**PCN#20150122000
LMX9838 Datasheet Changes including Product MIC Certification – Device
Symbolization to include MIC Certification
Information Only**

PCN Number:	20150122000	PCN Date:	01/23/2015
Title:	LMX9838 Datasheet Changes including Product MIC Certification – Device Symbolization to include MIC Certification		
Customer Contact:	PCN Manager	Dept:	Quality Services
Change Type:			
<input type="checkbox"/>	Assembly Site	<input type="checkbox"/>	Assembly Process
<input type="checkbox"/>	Design	<input checked="" type="checkbox"/>	Datasheet
<input type="checkbox"/>	Test Site	<input checked="" type="checkbox"/>	Packing/Shipping/Labeling
<input type="checkbox"/>	Wafer Bump Site	<input type="checkbox"/>	Wafer Bump Material
<input type="checkbox"/>	Wafer Fab Site	<input type="checkbox"/>	Wafer Fab Materials
<input type="checkbox"/>		<input type="checkbox"/>	Part number change
<input type="checkbox"/>		<input type="checkbox"/>	Assembly Materials
<input type="checkbox"/>		<input type="checkbox"/>	Mechanical Specification
<input type="checkbox"/>		<input type="checkbox"/>	Test Process

From	To
Device Symbol

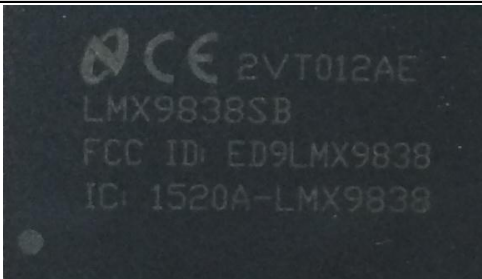
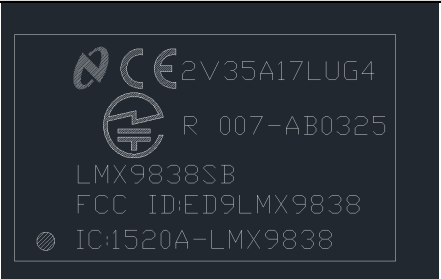
The LMX9838 datasheet will undergo updates including a change to reflect the recently obtained MIC Certification. Sections 8.3.4 and 11 have been updated to reflect this certification. Top-side Symbolization will accordingly be changed to reflect this MIC Certification Marking as shown below. No changes in testing, materials or manufacturing sites are associated with this MIC certification.
